**UPDATED GEOTECHNICAL INVESTIGATION  
PROSPECT ESTATES II DEVELOPMENT  
SANTEE, CALIFORNIA**

**SUBJECT:        UPDATED GEOTECHNICAL INVESTIGATION  
                  Prospect Estates II Development  
                  Santee, California**

**SUBJECT:       Response to Comments – Update Geotechnical Report  
                  Prospect Estates II  
                  Santee, California**

# TENTATIVE TRACT MAP FOR CONDOMINIUM PURPOSES DEVELOPMENT REVIEW PERMIT

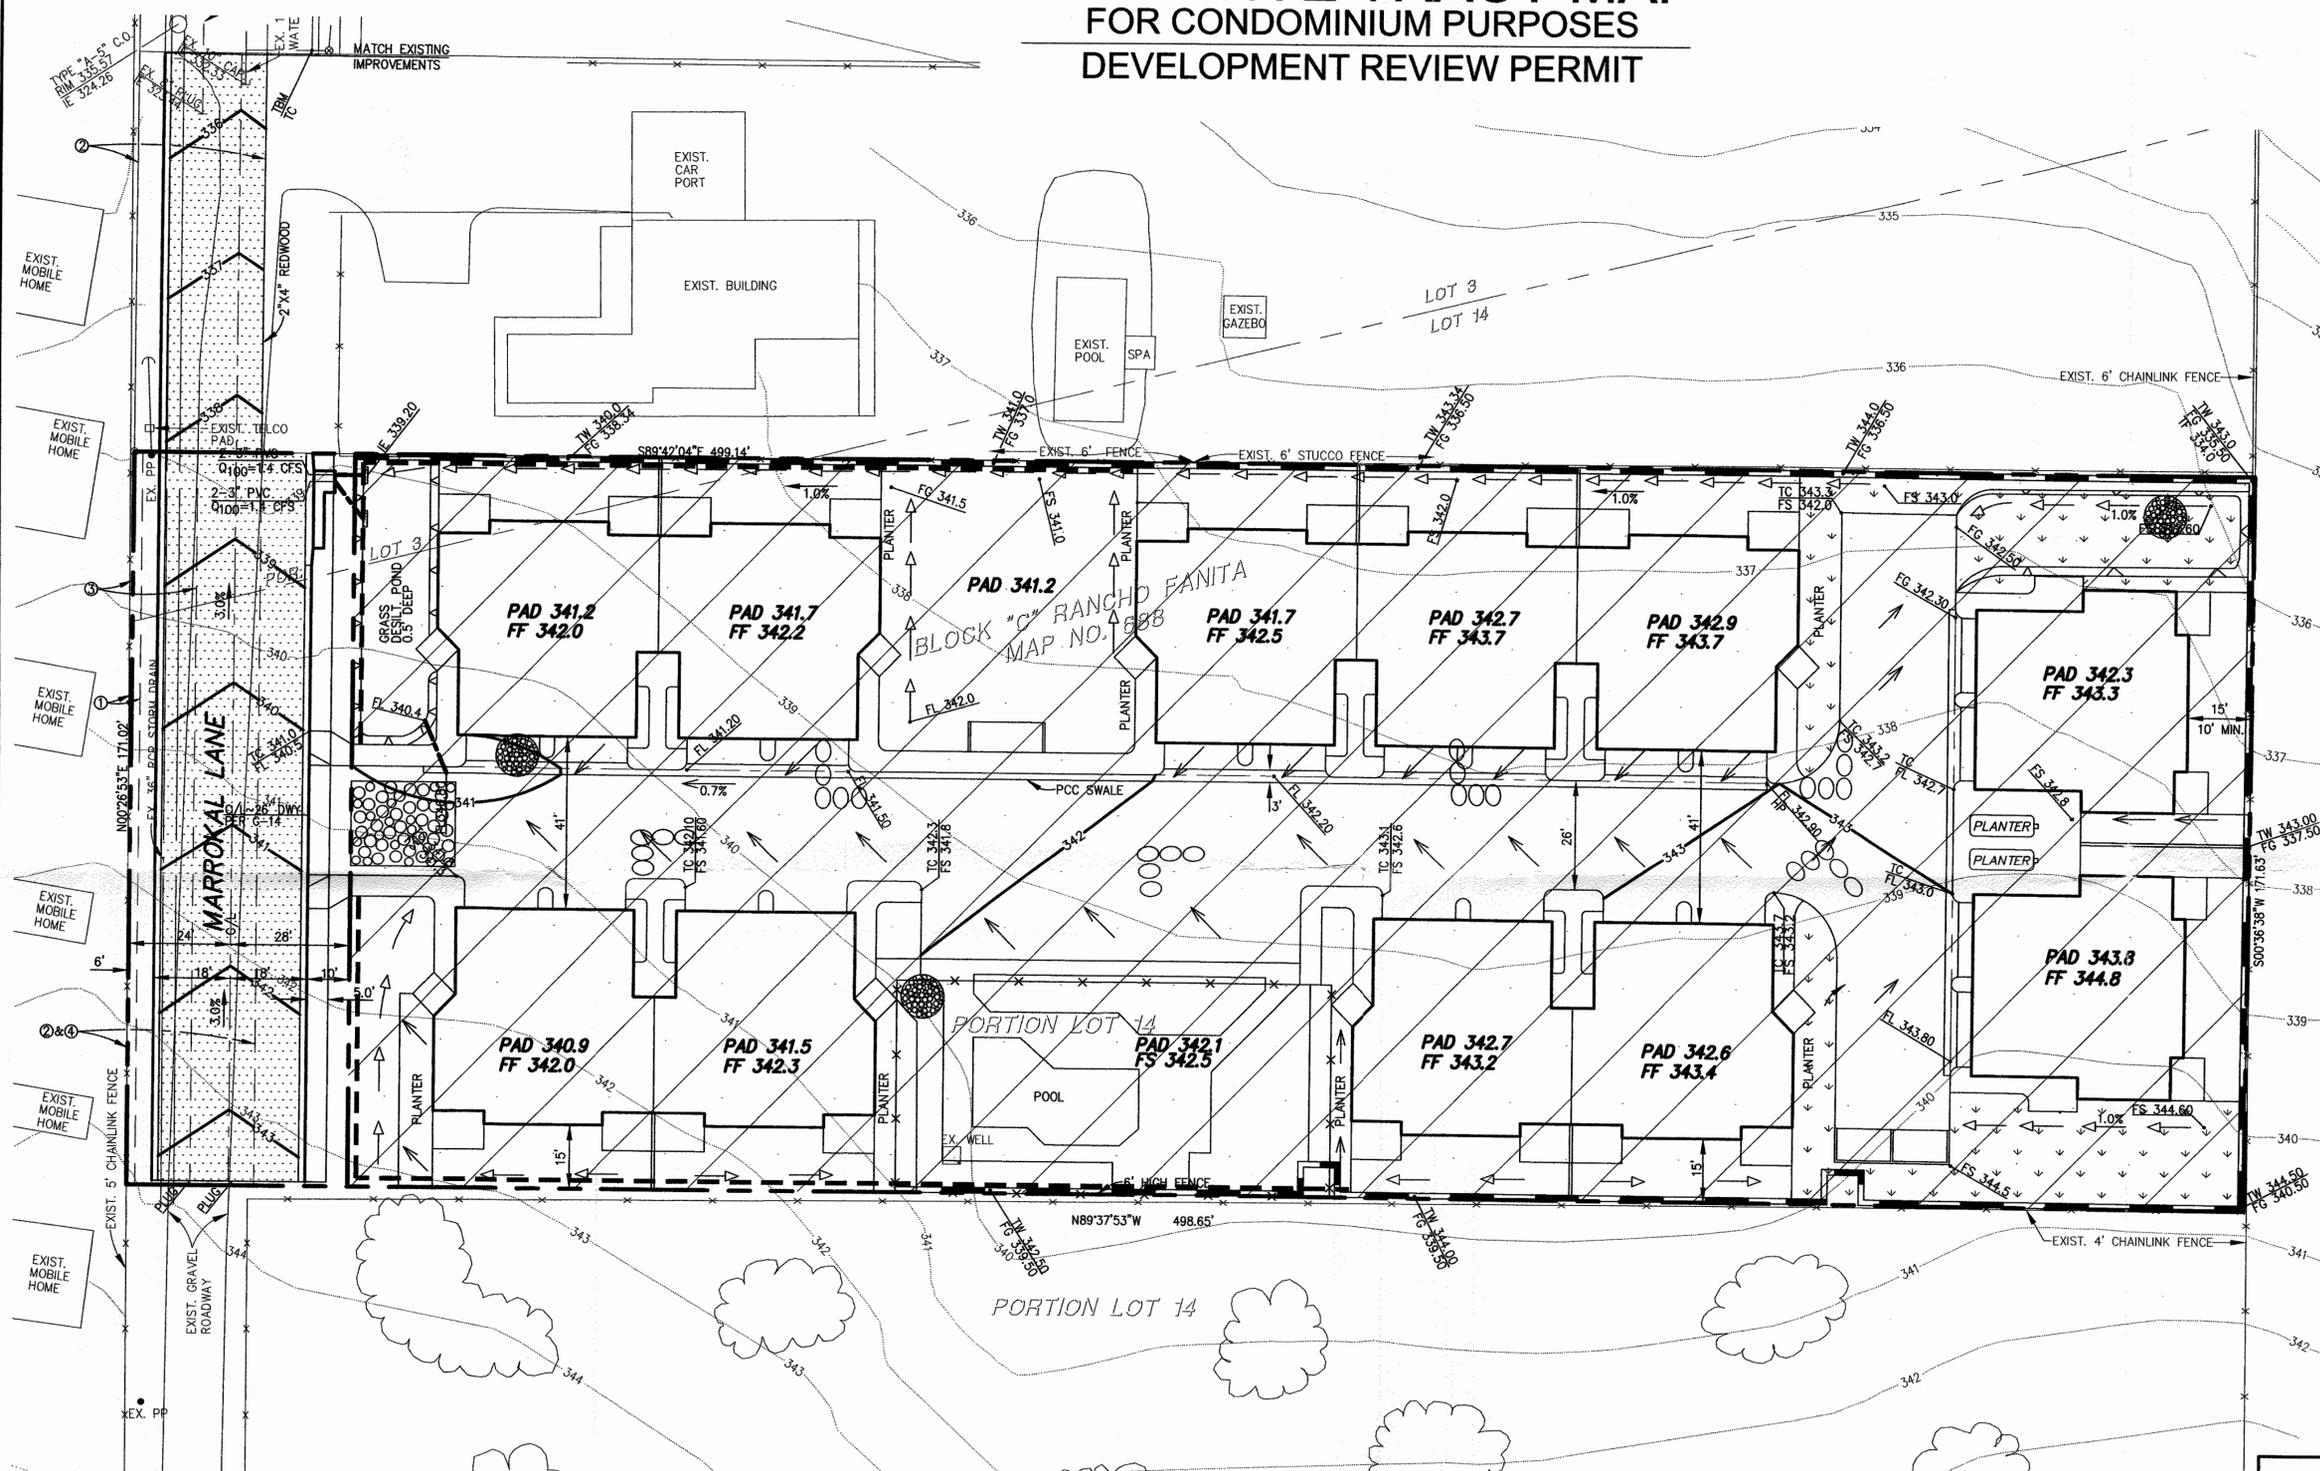
*6. Are there geotechnical constraints that would preclude partial infiltration within the planned basin at the northwest corner of the Please include a response within Criteria 6 of Worksheet C.4-1.*

Site to the north is undeveloped. Residential development is planned (see attached Tentative Map). Partial infiltration could negatively impact the foundations of perimeter retaining walls or other improvements close to the proposed basin. It could also create an undesirable long term liability exposure to the developers/owners of the Prospect Estates II project. We propose to add this information and conclusion to the geotechnical report.

**BOREHOLE  
PERCOLATION  
TEST I-1**

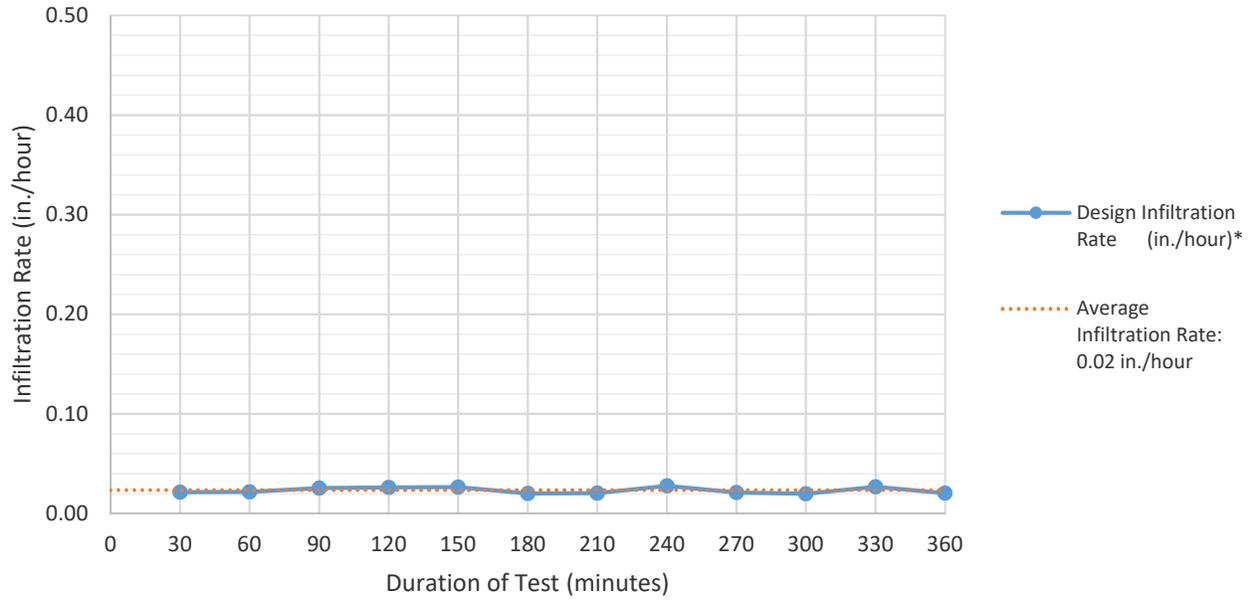
*4. It appears the geotechnical consultant has provided permeability results for other projects on remolded samples based on the designations. Has the geotechnical consultant performed in-place infiltration testing in the area of the planned storm water management basin? Can the basin be extended into the existing granitic rock and allow infiltration? The granitic rock is located about 5 feet below existing grade based on Boring B-1 performed Group Delta.*

Based on the Tentative Map and Preliminary Grading Plan (Polaris dated June 7, 2017) the base of the infiltration basin, which is at an elevation of approximately 336 feet above mean sea level (MSL) should extend into the existing granitic rock. On July 20, 2017, Group Delta drilled two additional borings in the area of the proposed infiltration basin. The borings extended into the granitic rock materials and were terminated approximately 2 feet below the bottom of the planned infiltration basin. Following drilling, the borings were converted to infiltration test holes and presoaked for about 24 hours. Infiltration testing was conducted in the two test holes on July 21, 2017 using the Borehole Percolation Test method (Riverside County Percolation Test, 2011) referenced in the City of Santee BMP Design Manual (2016). The average design infiltration rate was approximately 0.02 inches per hour, assuming a factor of safety of 2. The field test data sheets are attached to this letter.

**BOREHOLE  
PERCOLATION  
TEST I-2**

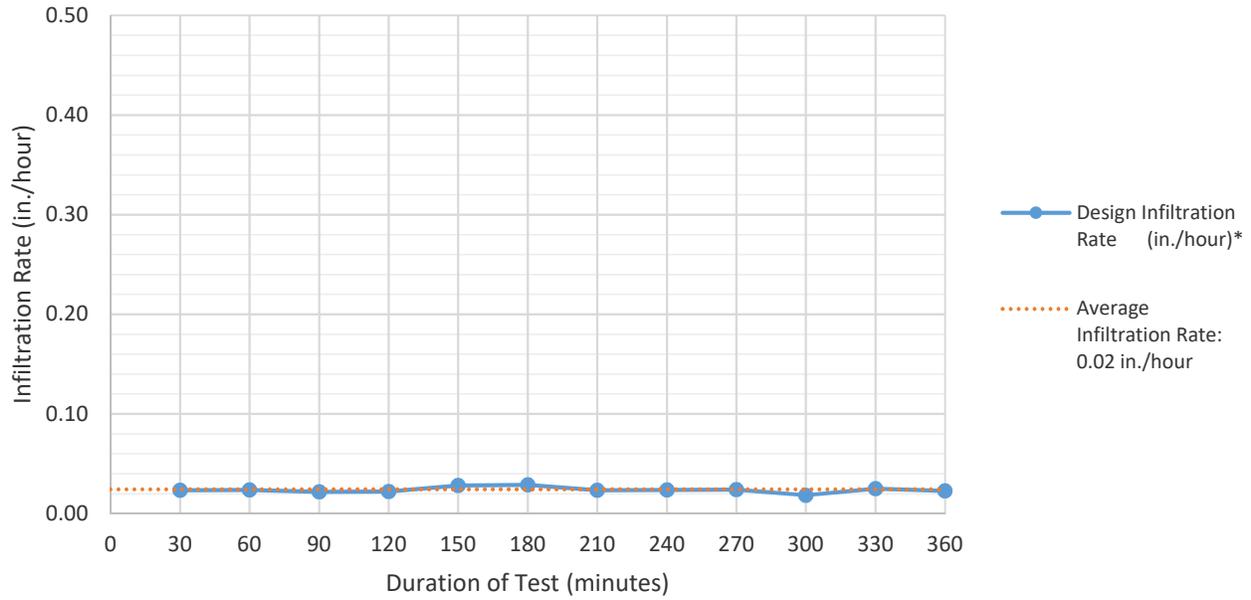
*5. Worksheet C.4-1 states the existing soil will possess an infiltration rate of less than 0.5 inches/hour within Criteria 1. Does the geotechnical consultant have test data on in-situ samples to evaluate the infiltration rate of less than 0.5 to 0.05 inches/hour to answer Criteria 5? Based on the elevation of the planned basin, will remolded compacted fill be present at the base of the basin?*

In addition, recent field infiltration testing conducted in the vicinity of the proposed infiltration basin resulted in an average design infiltration rate of about 0.02 inches per hour, assuming a factor of safety of 2. We propose to add this information and conclusion to the geotechnical report.
